Technical Notice

Issue Date: Dec. 2, 2016

Product Name:
WAFER-CV-D25501/WAFER-CV-N26001

Original item	Substitute item

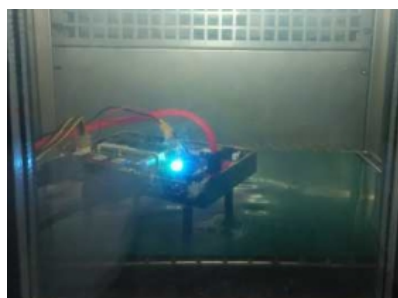
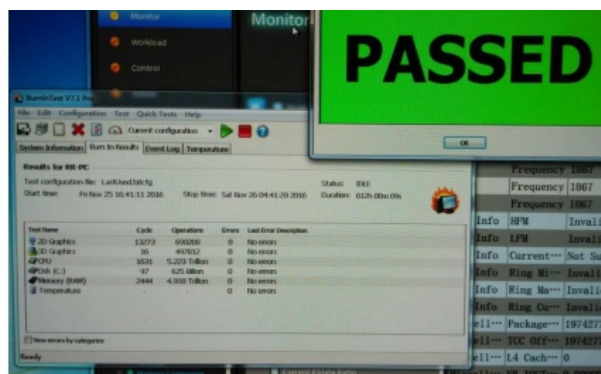
Change heatsink vendor and the material surface from nickel plating with sandblasting to nickel plating with satin finish
